# Diagrams to support ballots comments on 802.1AX-REV

**Norman Finn**  
nfinn@cisco.com

Figure 8-1—Internal view of an example Portal

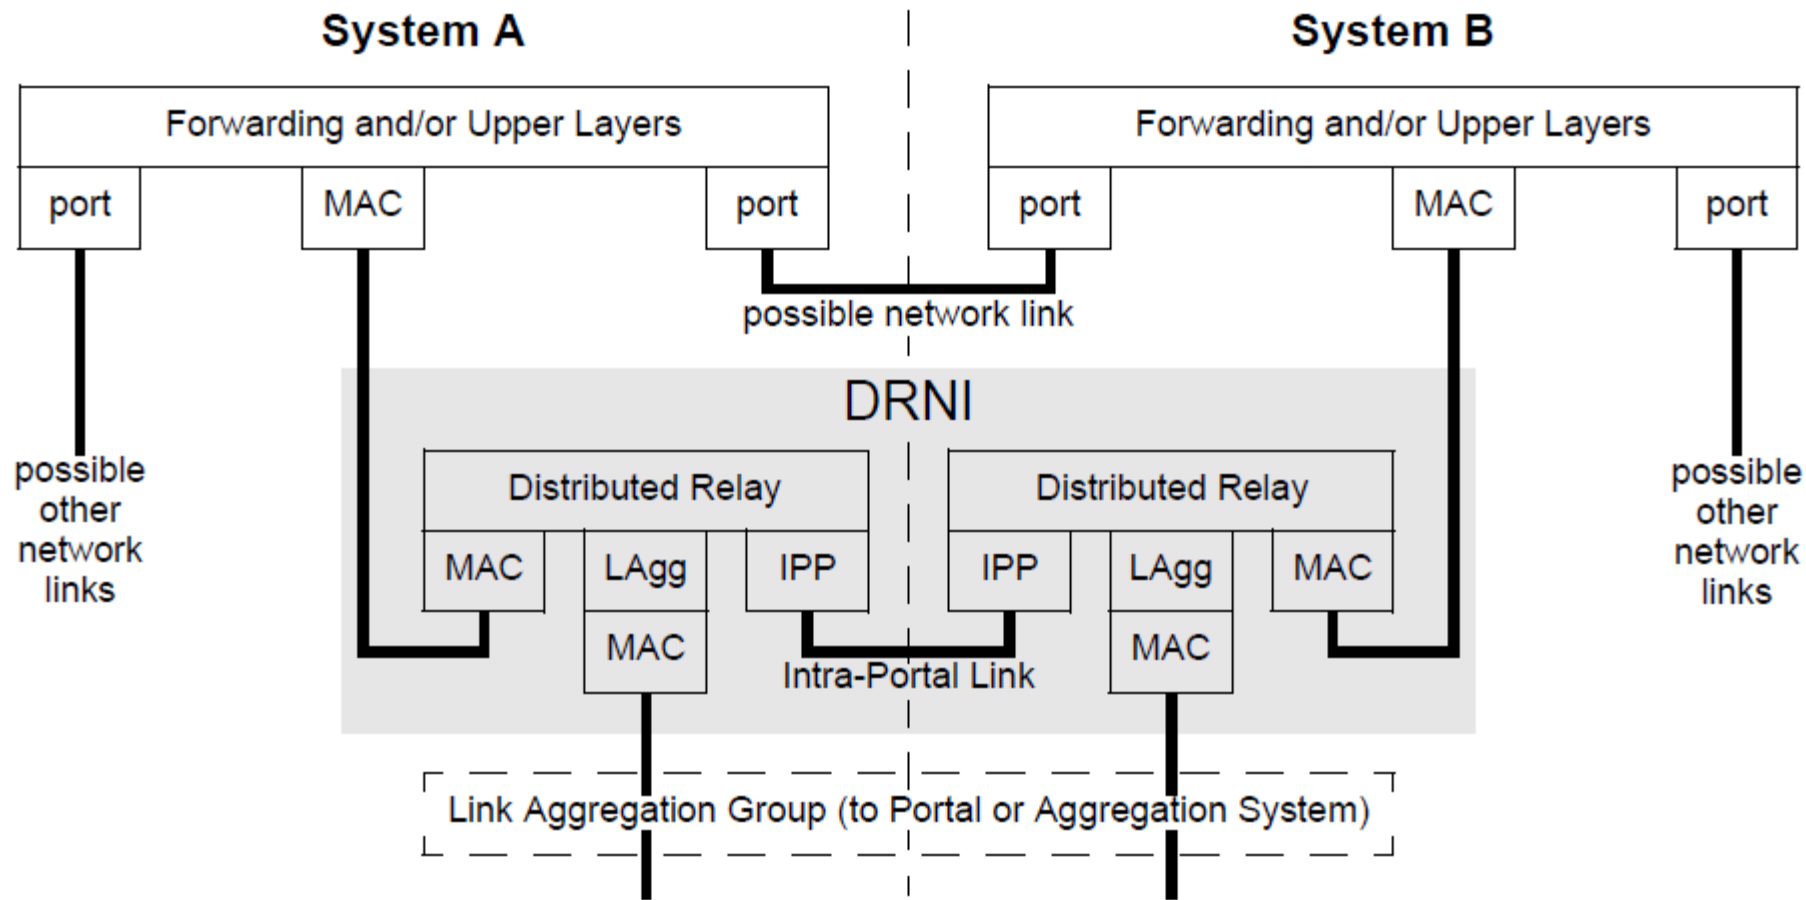
# Figure 8-1

Figure 8-2—External view of an example Portal

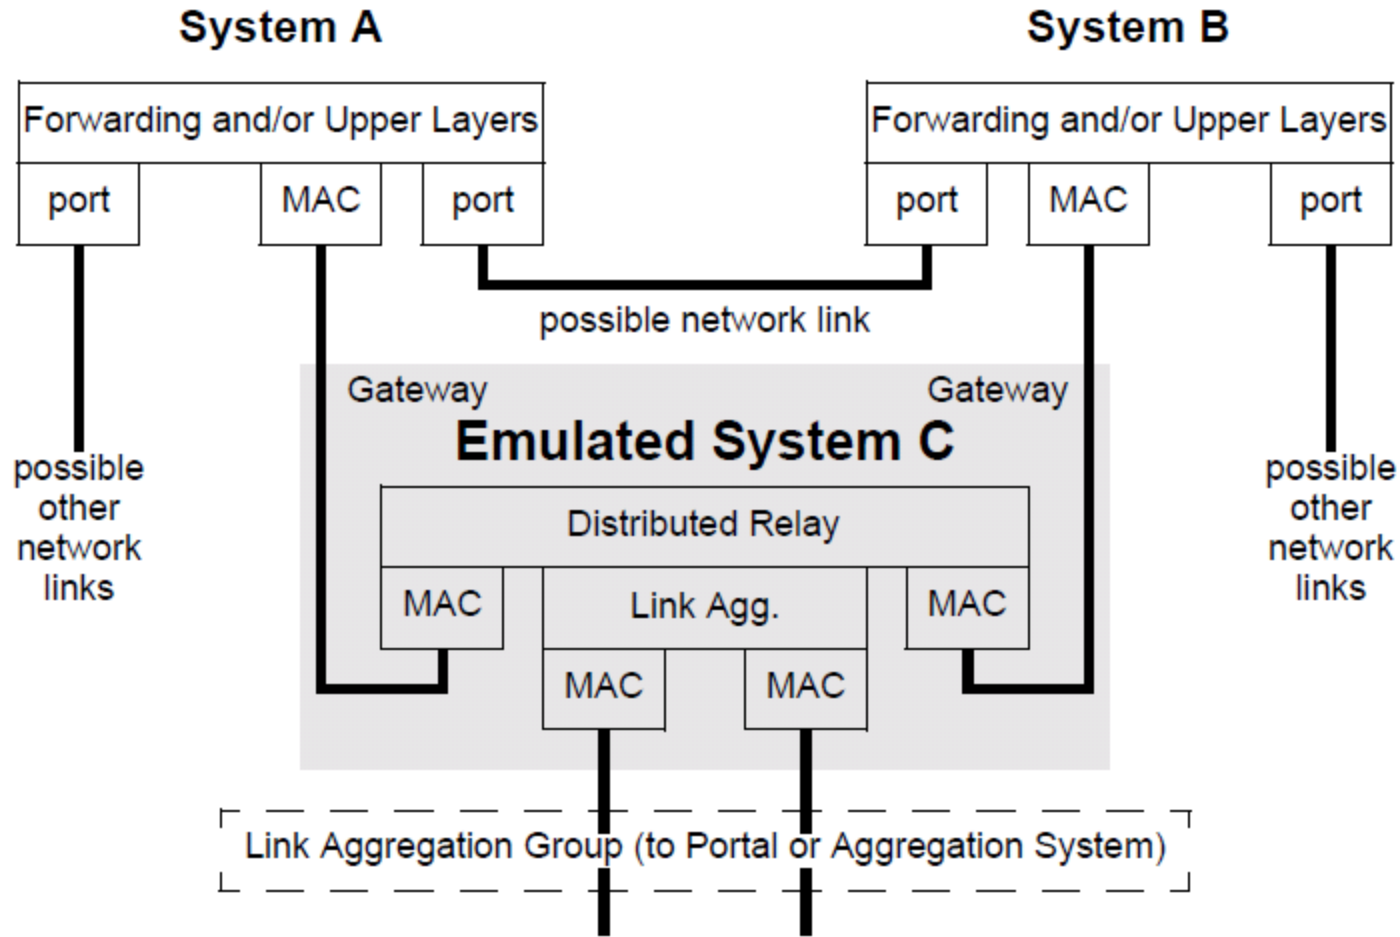
# Figure 8-2
